STAFF RECOMMENDATION
2012 Beechwood Avenue
March 20, 2019

Application: Demolition—Partial; New Construction—Addition
District: Belmont-Hillsboro Neighborhood Conservation Zoning Overlay
Council District: 18
Base Zoning: RS7.5
Map and Parcel Number: 10415042700
Applicant: Jeff Casella, Architect
Project Lead: Sean Alexander, sean.alexander@nashville.gov

<p>Description of Project: The applicant proposes to enlarge an historic one-story house with a two-story rear addition and to add two new front dormers and replace an existing front stoop with an uncovered porch deck.</p> <p>Recommendation Summary: Staff recommends approval of the proposed additions with the following conditions:</p> <ol style="list-style-type: none">1. The front dormers shall sit two feet (2') back from the front wall and two feet (2') down from the ridge; and2. The rear addition shall be no more than two feet (2') taller than the historic house and the taller portion shall be stepped in two feet (2') from the sides of the historic house; and3. The metal roof color and the window and door selections shall be approved administratively prior to purchase and selection; and4. If the HVAC units are relocated, they sha

1 SOUTH ELEVATION (FRONT)
SCALE: 1/8" = 1'-0"

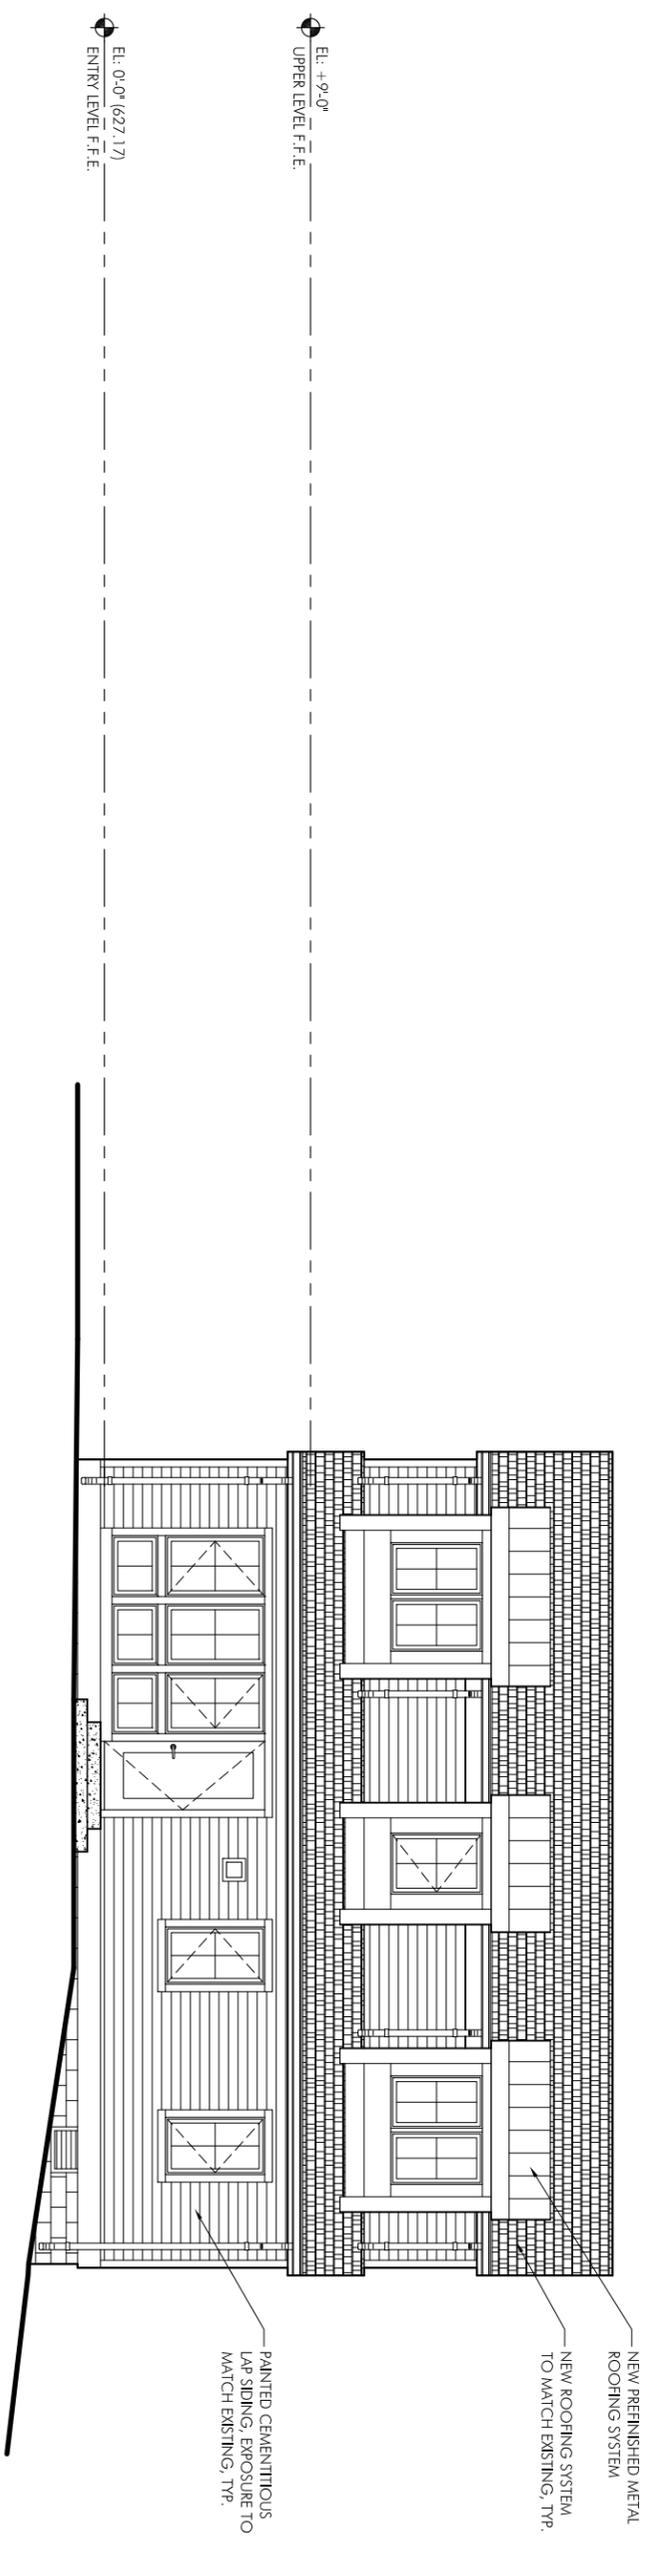
Height & Scale: The two new front dormers will be six feet (6') wide, sitting back one foot (1') from the first story wall and six inches (6") down from the ridge of the roof. Previously the Commission has required dormers to sit two feet (2') back from a first story wall and two feet (2') down from an historic roof ridge. The width of the dormers is similar to the windows below, which is a typical scale for historic dormers. The dormers will be located above the window openings on the first story, maintaining the existing building's balance and symmetry. With a condition that the dormers are reduced to sit two feet (2') back from the first story wall and two feet (2') down from the roof ridge, staff finds that the dormers are appropriately scaled.

Staff finds that, with a condition that the dormers are revised to sit two feet (2') back from the first story wall and two-feet (2') below the ridge, the height and scale of the proposed front dormers would be appropriate, but the rear addition does not meet Sections II.B.1.a and II.B.1.b of the design guidelines.

1. The front dormers shall sit two feet (2') back from the front wall and two feet (2') down from the ridge; and
2. The rear addition shall be no more than two feet (2') taller than the historic house and the taller portion shall be stepped in two feet (2') from the sides of the historic house; and
3. The metal roof color and the window and door selections shall be approved administratively prior to purchase and selection; and
4. If the HVAC units are relocated, they shall be behind the midpoint of the building or on the rear.

2 EAST ELEVATION (SIDE)
SCALE: 1/8" = 1'-0"

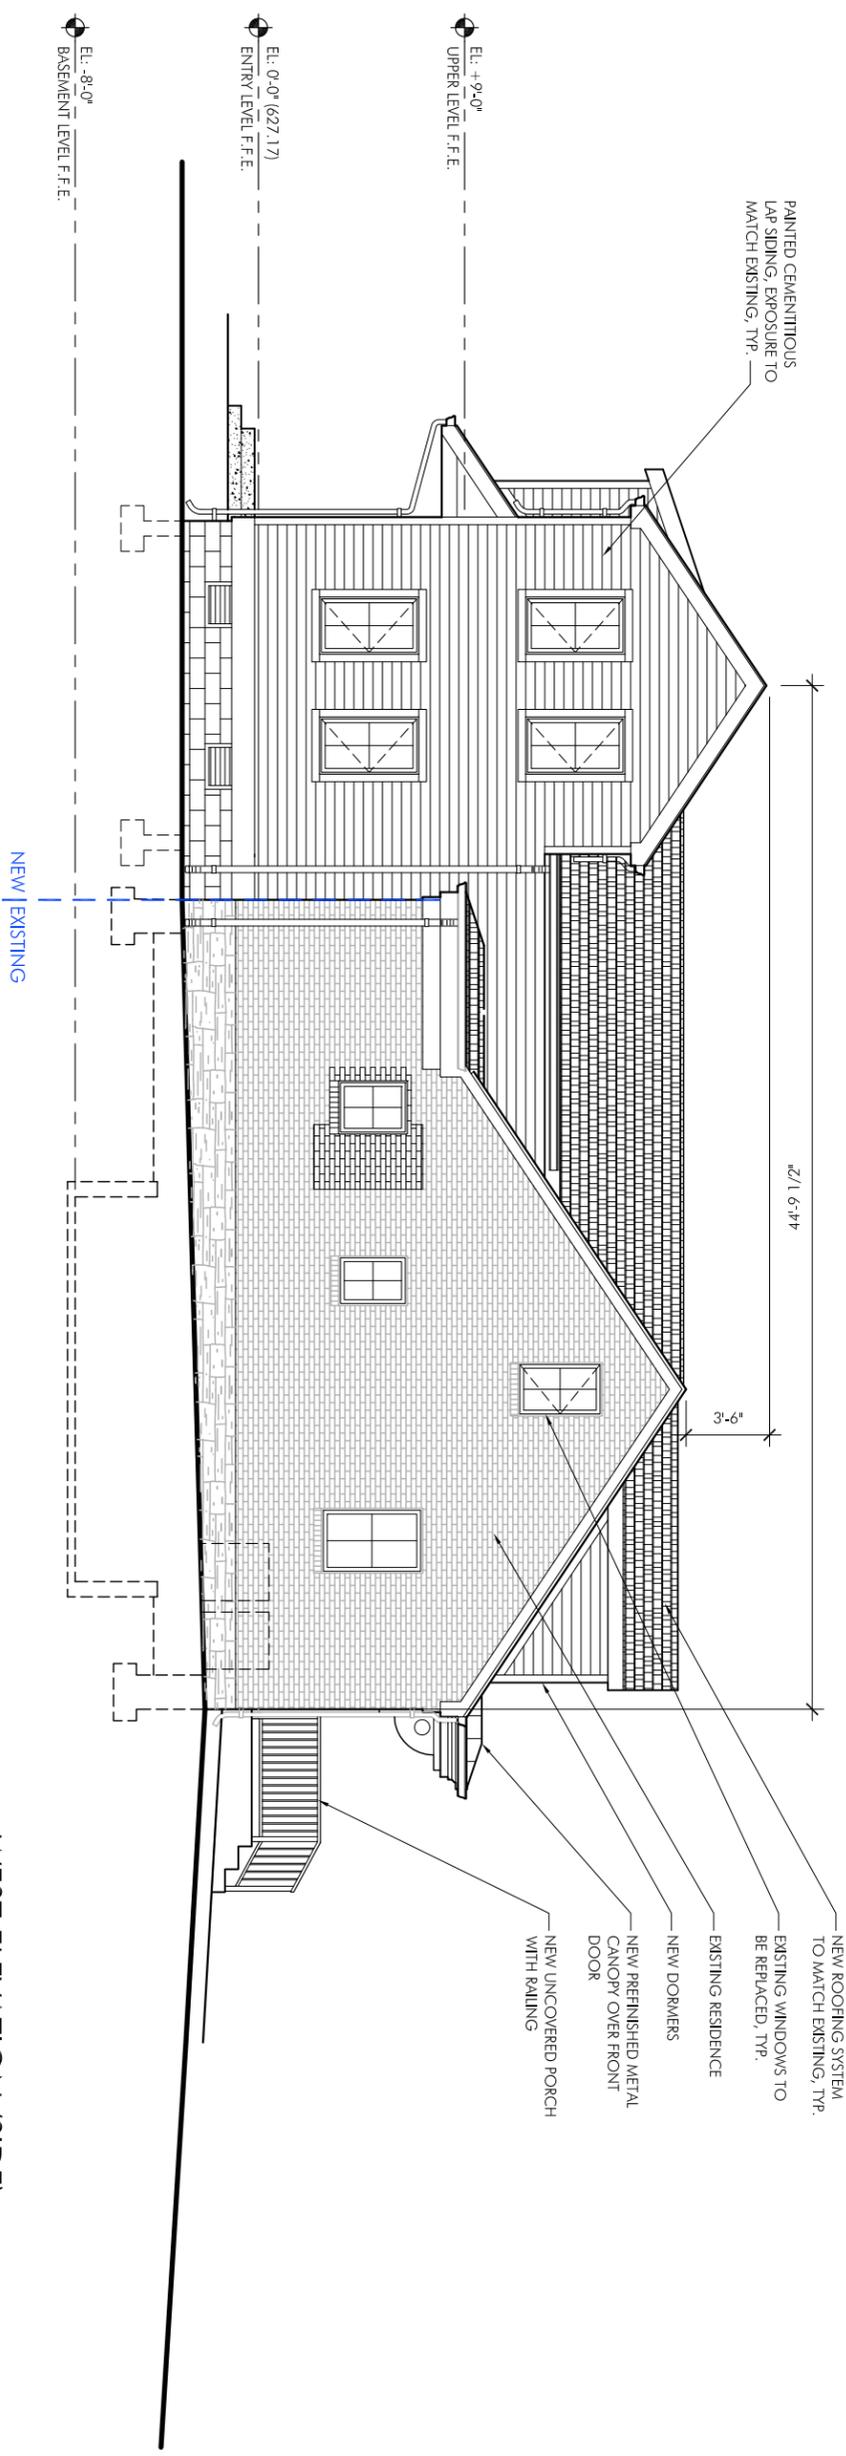
The proposed rear addition will be two-stories tall with an eave height of seventeen feet, six inches (17'-6") and a ridge height of twenty-three feet, six inches (23'-6"). This eave height is thirteen feet, six inches (13'-6") taller than the eaves of the historic house, and the ridge is three feet, six inches (3'-6") taller than the ridge of the historic house. Where two-story additions to one-story houses and additions that are taller than the historic building have been approved by the Commission previously, the precedent of the Commission in recent years has been to allow additions to be up to two feet (2') taller than the historic house, provided that the taller addition is stepped in two feet (2') from the sides of the historic house.

As previously described, the ridge of the addition will be three feet, six inches (3'-6") taller than the roof of the historic house and the eaves will be thirteen feet, six inches (13'-6") taller than the eaves of the historic house. Additions should generally not have a greater number of stories than an historic house, however the Commission has allowed additions to be as much as two feet (2') taller than the historic house with the requirement that the taller addition is stepped in two feet (2') from the sides of the historic house.
